**RE: DA REFERENCE DA-1443/2016 JRPP REF 2016HCC055 – PROPOSED SENIORS HOUSING – 14 HALYARD WAY, BELMONT**

## ATTACHMENT 2 – AMENDED LAYOUT FOOTPRINT

PROPOSED SENIORS LIVING VILLAGE LAYOUT  
SITE ANALYSIS PLAN  
Lot 803 DP1156934  
14 HALYARD WAY, BELMONT

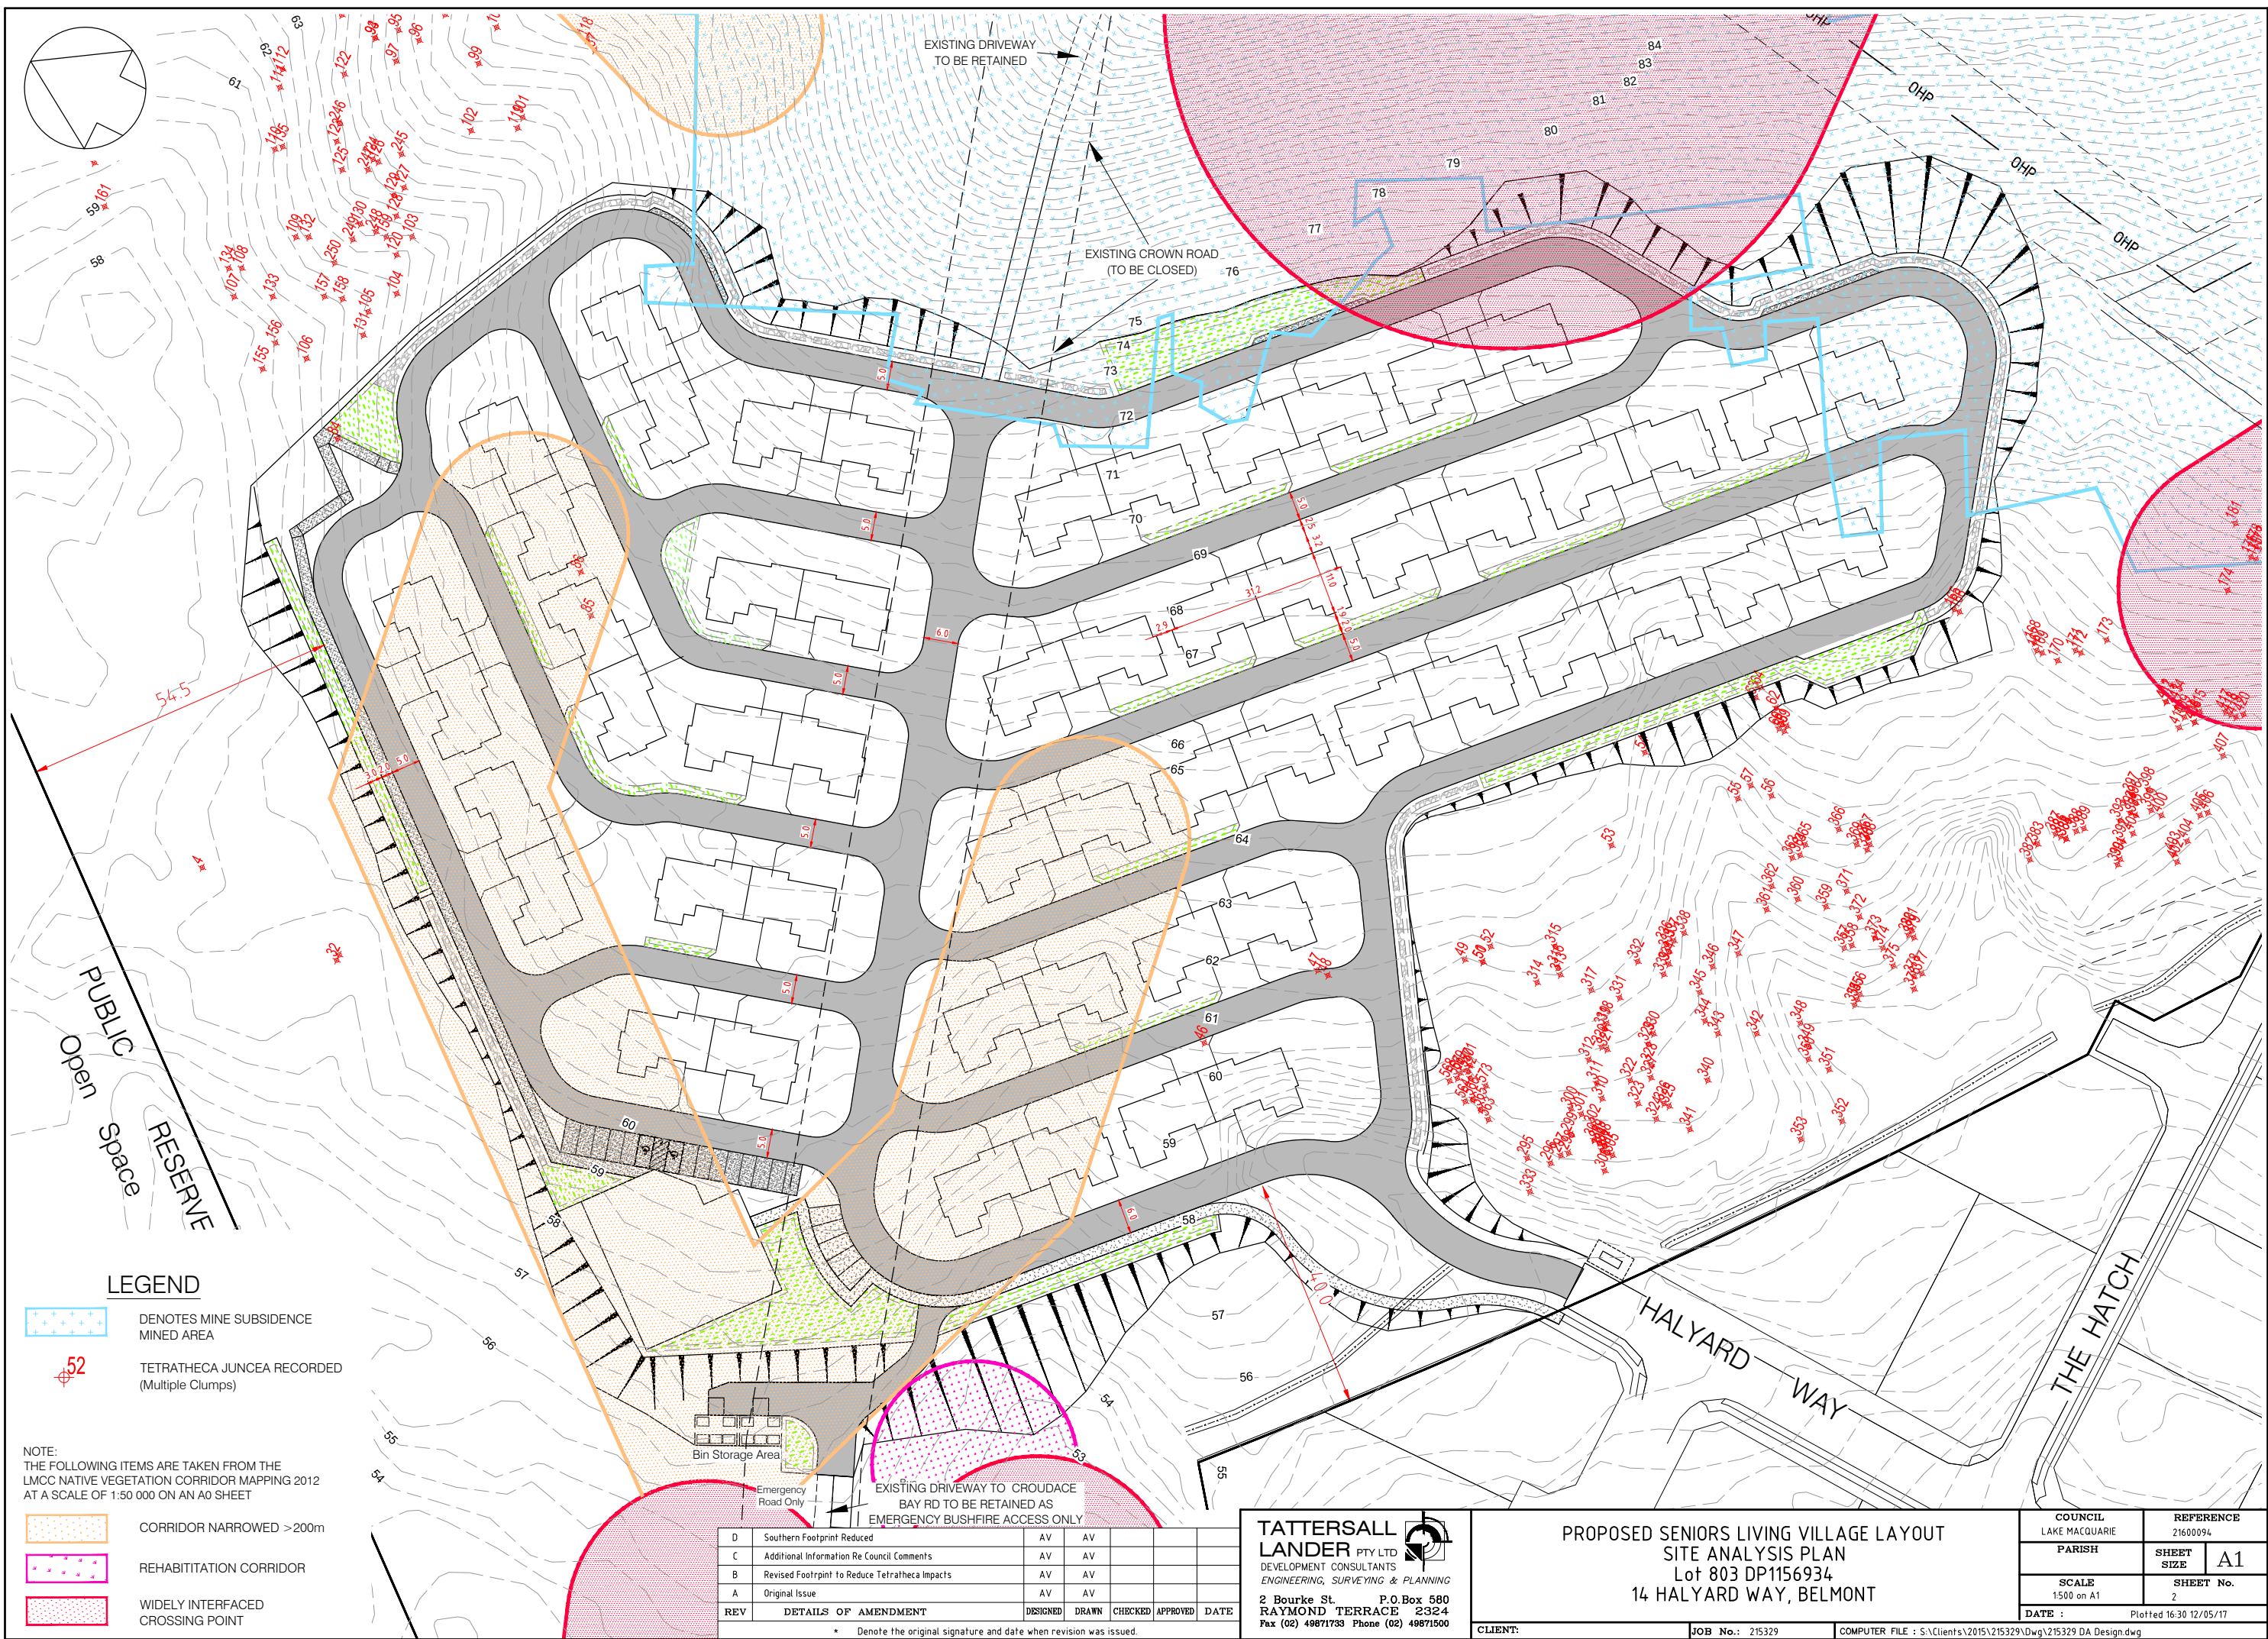
### **Discussion regarding the revised plan;**

As recommended by Biosis, the revised scheme reduces the eastern part of the development footprint to retain and provide for a larger corridor of retained higher quality bushland to the north east.

In addition to the ecological benefit, this revised scheme moves the development footprint out of the undermined areas. It also avoids the steeper parts of the site which reduces the amount of cut and fill and supports a prominent ecological corridor around the site.

| B   | Revised Footprint to Reduce Tetraheca Impacts | AV       | AV    |         |          |      |  |

PROPOSED SENIORS LIVING VILLAGE STAGING PLAN  
STAGING PLAN  
Lot 803 DP1156934  
14 HALYARD WAY, BELMONT

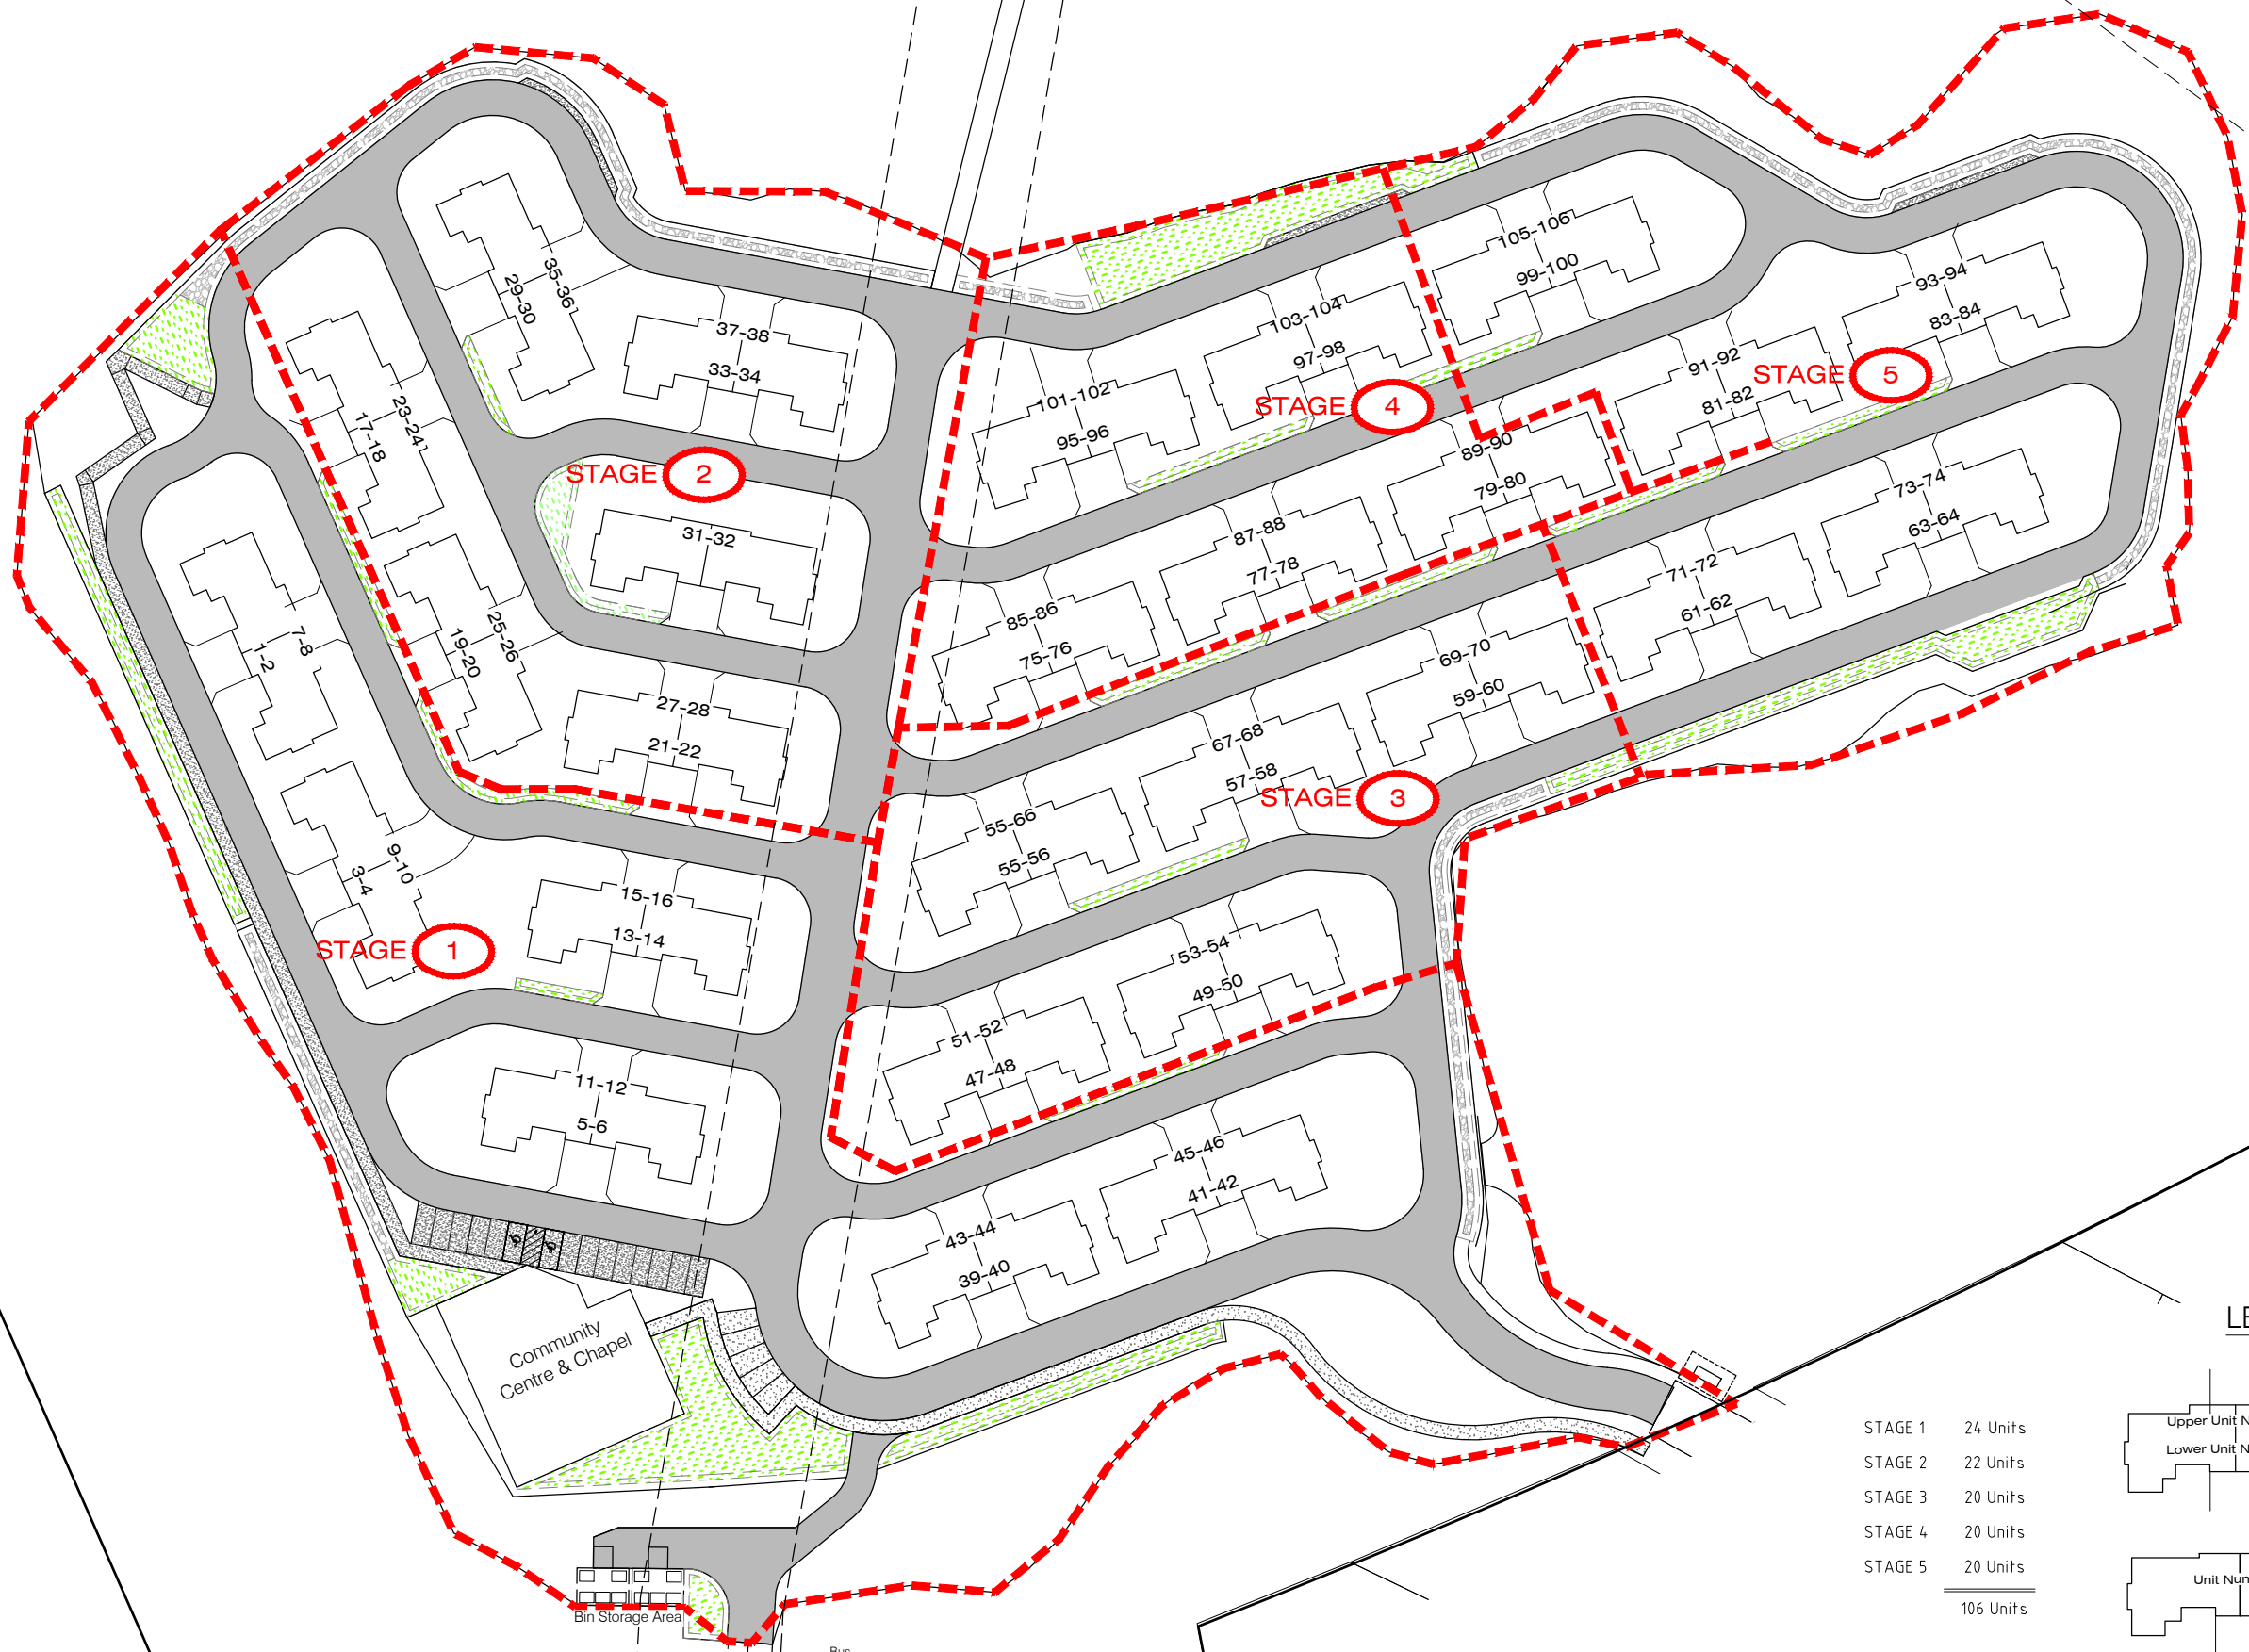
| B   | Revised Footprint to Reduce Tetrahedra Impacts | AV       | AV    |         |          |      |  |
